Access Compliance Report

Public Rights-of-Way

(Curb Ramps)

Intersection ID: 10970	Main Street: FRAZIER_AV	Cross Street: MONTGOMERY_ST	Location:	N
ADA ID: 1D78732E71A3	Ramp Type: PerpDiag	Initial Pass/Fail: Fail	Overall Compliance: No	Severity Score: 36.25
Codes/Mitigation Info/Possible Solution		Field Measurements/Component Compliance

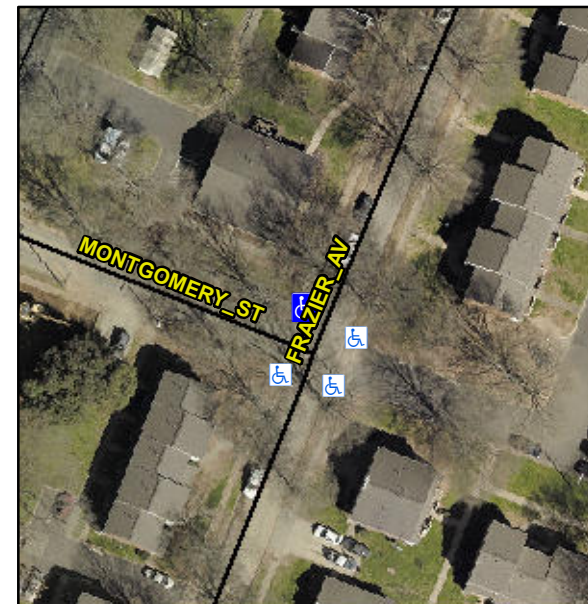
Not Found, R304.5.1, R304.5.3

Compliance	Description	Data	Compliance	Description	Data
N/A	Ramp Length (in)	46.0	Yes	Ramp Slope (%)	5.3
No	Ramp Width (in)	27.0	No	Ramp XSlope (%)	2.5
N/A	Flare Type LT	N/A	N/A	Flare Type RT	N/A
N/A	Flare Slope LT (%)	N/A	N/A	Flare Slope RT (%)	N/A
N/A	Flare Traversable LT?	N/A	N/A	Flare Traversable RT?	N/A
N/A	Landing Length (in)	N/A	N/A	DWS Provided?	N/A
N/A	Landing Width (in)	N/A	N/A	DWS Contrast?	N/A
N/A	Landing Slope (%)	N/A	N/A	DWS Length (in)	N/A
N/A	Landing X Slope (%)	N/A	N/A	DWS Full Width?	N/A
N/A	Landing Curb? (Y/N)	N/A	N/A	DWS Offset (in)	N/A
N/A	Shared Landing?	N/A			
N/A	Gutter Ponding?	N/A	N/A	Gutter Slope (%)	N/A
N/A	Gutter Lip Ht (in)	1.5	N/A	Gutter X Slope (%)	N/A
N/A	Painted X Walk1?	No	N/A	Painted X Walk2?	No
	X Walk 1 Direction	To SW		X Walk 2 Direction	To SE
N/A	X Walk 1 Width (in)	N/A	N/A	X Walk 2 Width (in)	N/A
	X Walk 1 Slope (%)	0.8		X Walk 2 Slope (%)	2.5
	X Walk 1 X Slope (%)	3.3		X Walk 2 X Slope (%)	2.6

Remove & Replace Curb Ramp With Two New Directional Ramps or Equivalent.
